**From:** Mitman, Jeffrey  
**Sent:** Wednesday, October 20, 2010 2:43 PM  
**To:** Ferrante, Fernando  
**Subject:** FW: OUO/SRI-FW: Information Related to an NRC External Flood Inspection Issue at Oconee  
**Attachments:** [Redacted] <sup>Outside of Scope</sup> Wilson Independent Review HDR Comments.pdf; Wilson Independent Review.pdf; Young Independent Reivew HDR Comments.pdf; Young Independent Review.pdf

**REVIEW OF THE HDR ENGINEERING, INC. TWO-DIMENSIONAL SIMULATION OF FLOW IN THE VICINITY OF OCONEE NUCLEAR STATION RESULTING FROM A HYPOTHETICAL DAM FAILURE SCENARIO AT LAKE JOCASSEE.**

**Subject: Independent Technical Review  
HEC-RAS and SRH-2D Hydraulic Modeling  
Wilson Engineering Project WE10009**

FIGURE 1 - CROSS SECTION PLACEMENT DOWNSTREAM FROM KEOWEE DAM

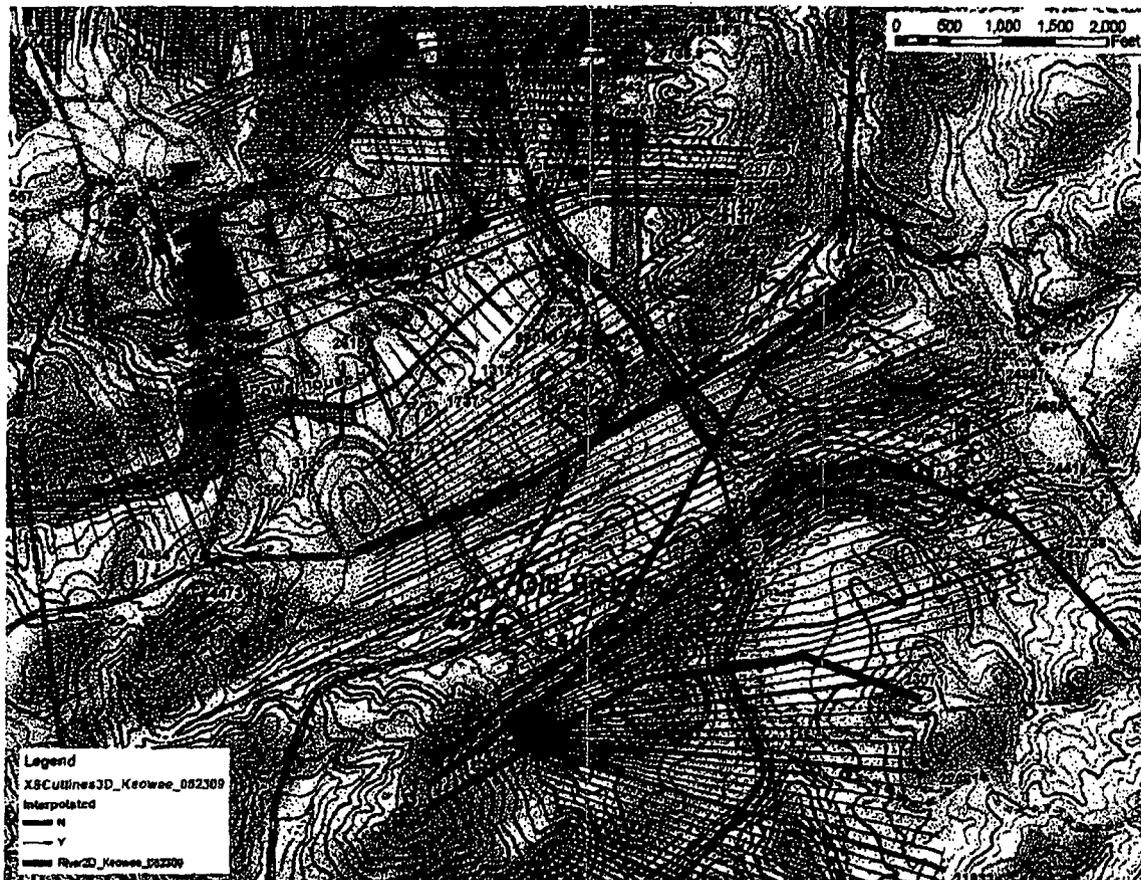
HEC-GeoRAS was used to acquire cross sections from a DTM and specified cut lines. This approach allowed a great deal of geometric information to be represented in the HEC-RAS model. Spot-checking of the cross section alignments revealed a few areas where cross section alignment should be reconsidered. Figure 1 illustrates one such location downstream from Keowee Dam: the cross sections were located in the vicinity of "Big Bend" assuming that the saddle between Old Pickens and Big Bend would be overtopped and during the peak event would act as the main channel. Although this may be true, the normal flow channel would be better represented using the four cross sections overlaid as thick red lines.

The selection of Manning's  $n$  roughness coefficients was generally reasonable, however the assignment of the coefficients in some places was incorrect. For example, in the reach which comprised Keowee Lake, cross section  $n$  values were assigned based on bank station placement, and in some places the banks were set too far from the normal pool lake extents, thus causing areas that are currently heavily wooded to be assigned too low  $n$  values. Similarly,  $n$  values in the vicinity of Big Bend (Figure 1) were inappropriate.

FIGURE 2 - MIXED FLOW EXPONENT COMPARISON, KEOWEE RIVER - UPSTREAM OF EASTATOE RIVER

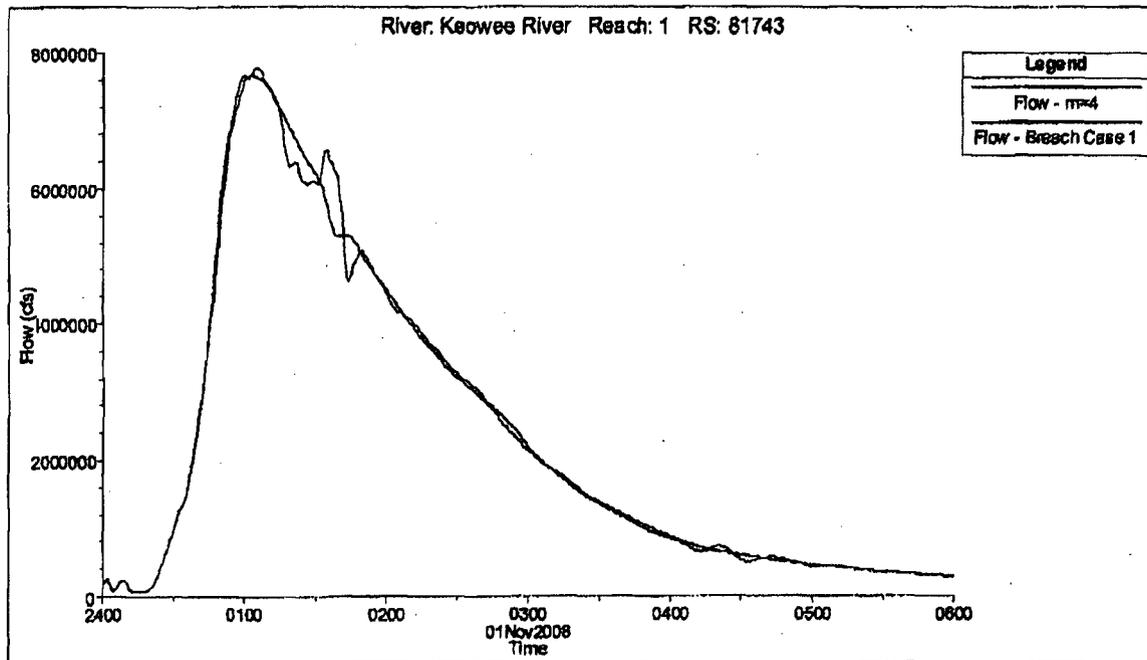
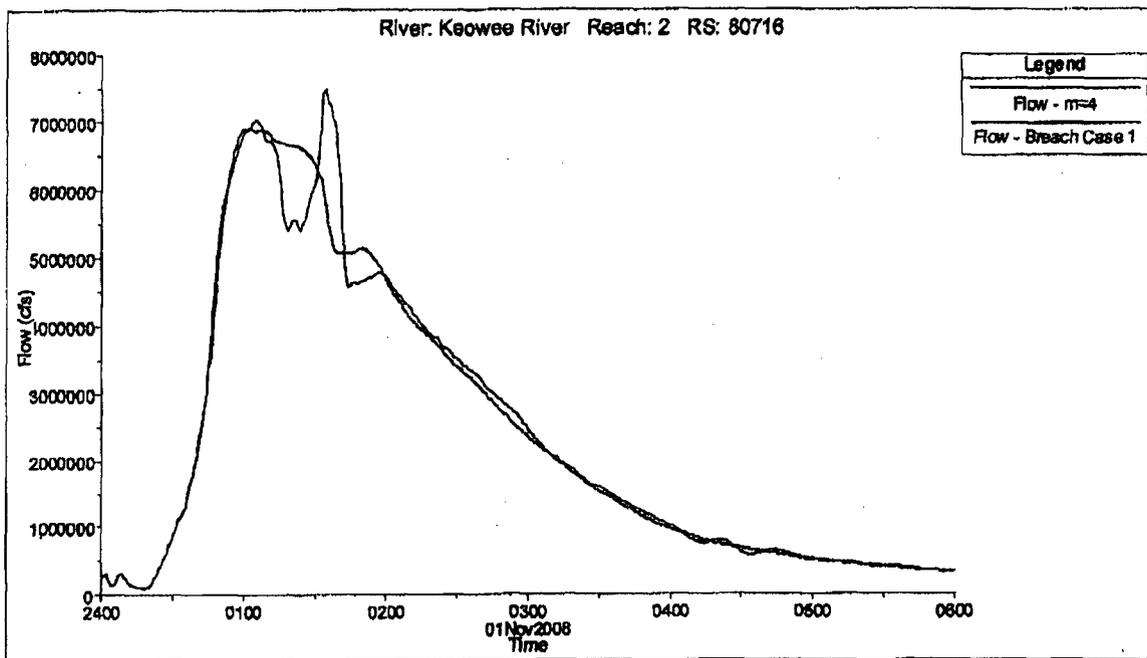
I changed the mixed flow exponent, m, from the default value of 10 to 4 to determine the impact on the occurrence of non-convergence errors, average error, and predicted peak elevations. All "solver went unstable" messages were eliminated and the errors associated with the "iterations exceeded" messages and predicted water surface elevations were significantly reduced:

Reduction of this factor decreased the numerical error in the solution and caused a substantial dampening of the predicted peak elevations. An examination of two hydrographs illustrates that the results from the analysis using m=4 produces more realistic, monotonic hydrographs. Both hydrographs are taken from a typical HEC-RAS model run which experienced numerical oscillations on the Keowee River (Breach Case 1), just upstream and downstream from the confluence with the Eastatoe River, are shown in Figure 2 and Figure 3.

Based on this analysis, use of the non-default mixed flow exponent yields more reasonable results, and should be used in future.

FIGURE 6 - BREACH FORMATION STEP FUNCTION

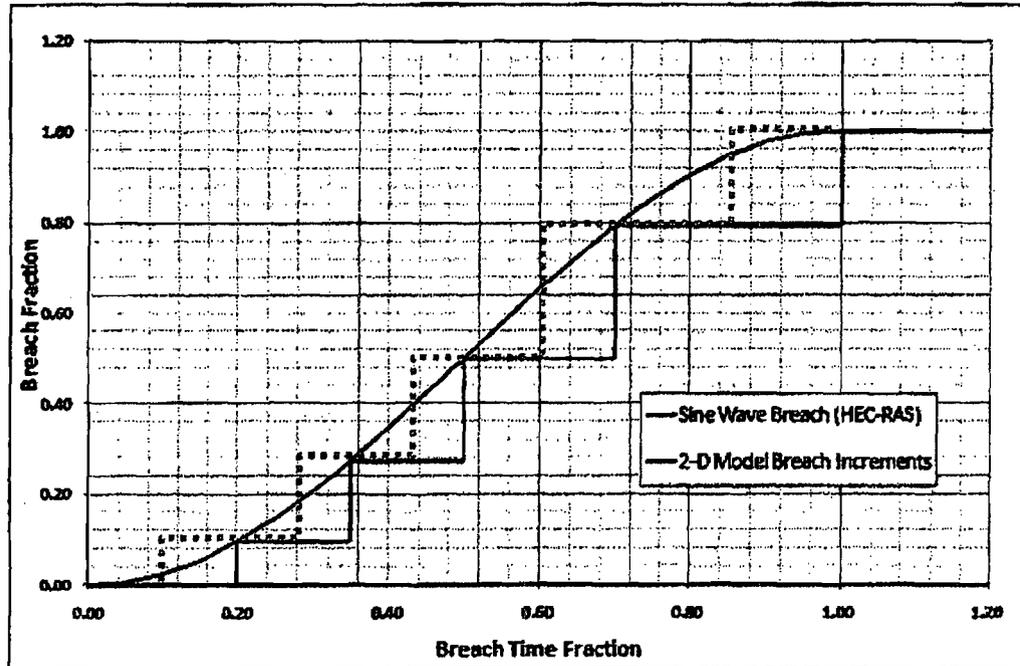
Section 3.4 of the SRH-2D report described how the breaches had to be simulated using the 2-D model: the sine wave breach formation was approximated using a 6-part step function by stopping the model at a specific time, adjusting the mesh to represent the partial breach, and restarting the simulation. As shown in Figure 8 of that report, the timing of these manual steps lagged the HEC-RAS sine-curve function. In my opinion, a better approach would have been to have the steps straddle the sine curve, as indicated in Figure 6 as a green dotted line. This would have enabled a slightly more faithful representation of the HEC-RAS breach formation, shifting it about 10% of the total breach formation time (in the case of Keowee, about 15 minutes). The impact of this time shift was not determined, but it is not expected to be large, relatively speaking.
